PARTS & SERVICE NEWS

REF NO.	AA01013
DATE	January 11, 2000

SUBJECT: RECTIFIER PANEL (PB6489) ON ELECTRIC DRIVE DUMP TRUCKS

PURPOSE: Inform the field of a modification of the Repair / Replacement Procedure of Rectifier Panel (PB6489 and GE0557)

Figure 1. Heat Sink Assembly GE0558

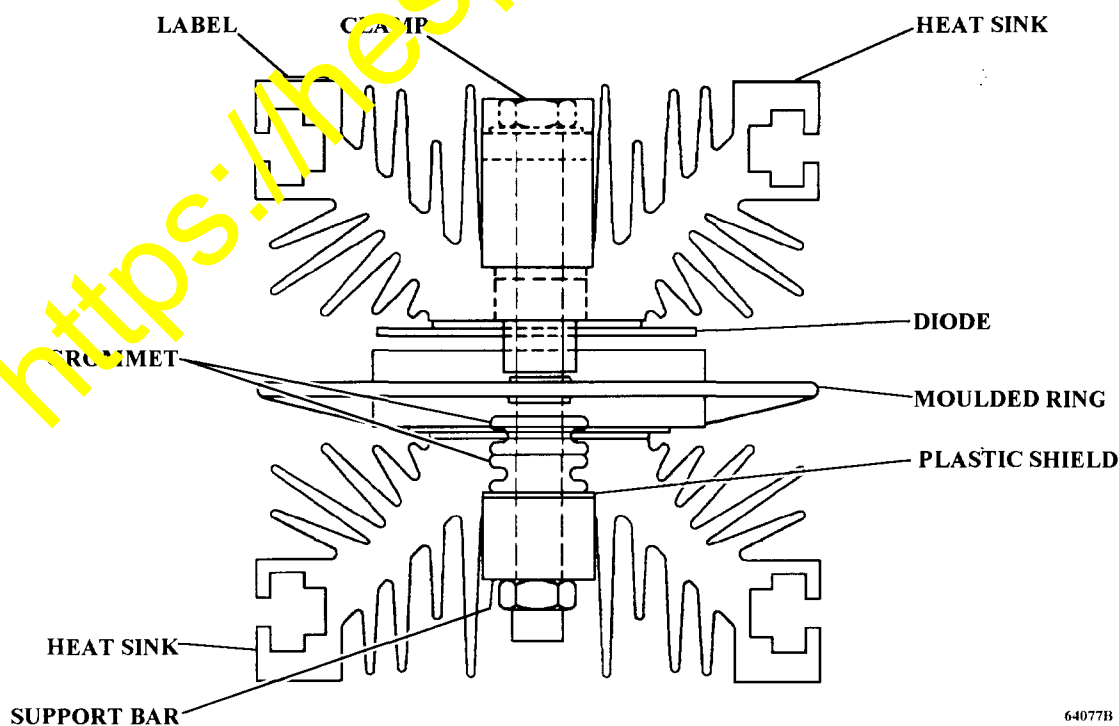
The rectifier panel contains six heat sink assemblies. All previous heat sink assembly part numbers have been superseded by part number (GE0558). Therefore, heat sink assembly (GE0558) should be used to replace all failed heat sink assemblies. Refer to Figure 1.

Figure 2 Schematic and Polarity Chart

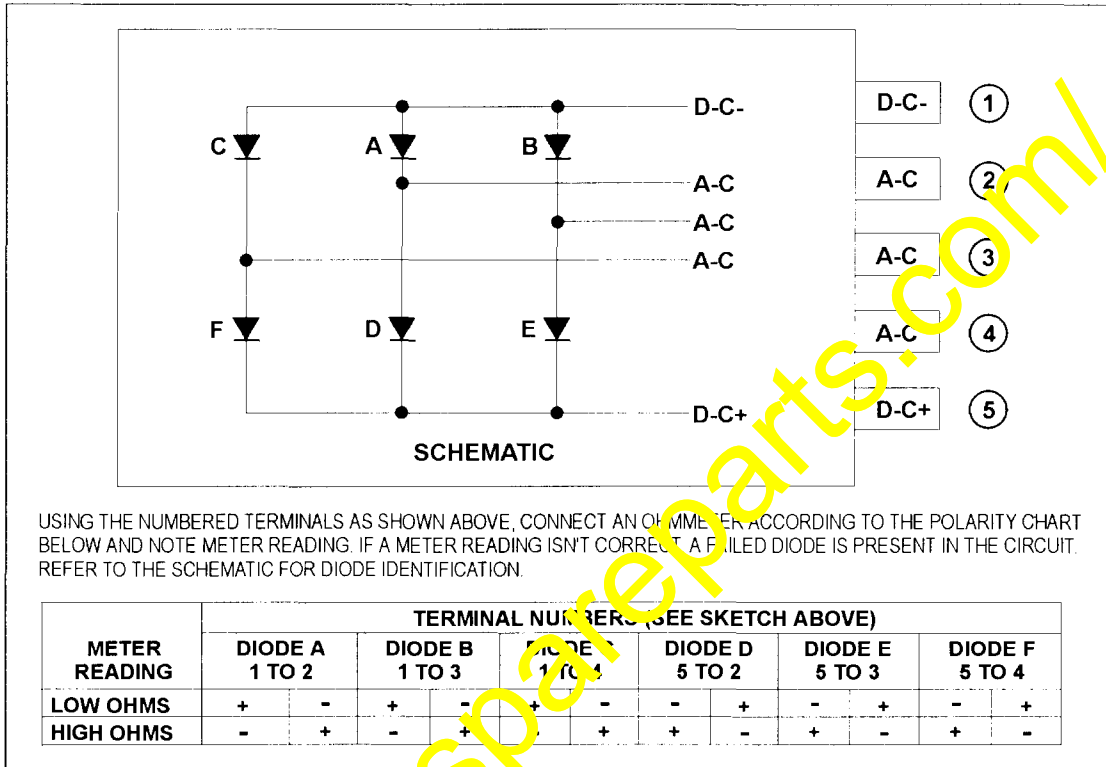
Only failed heat sink assemblies should be replaced. If a problem is suspected in the rectifier panel, use the following procedure and refer to Figure 2 in order to troubleshoot the rectifier panel:

1. Remove the cover and inspect the interior of the panel for loose busbar connections.
2. Check for a failed diode as follows:
 - a. Remove all external cables from a-c, d-c(+) and d-c(-) busbar connections.
 - b. Using an ohmmeter, connect the (+) and (-) leads according to Figure 2 and note the readings.
3. If a failed diode is found, replace the heat sink assembly as a unit.
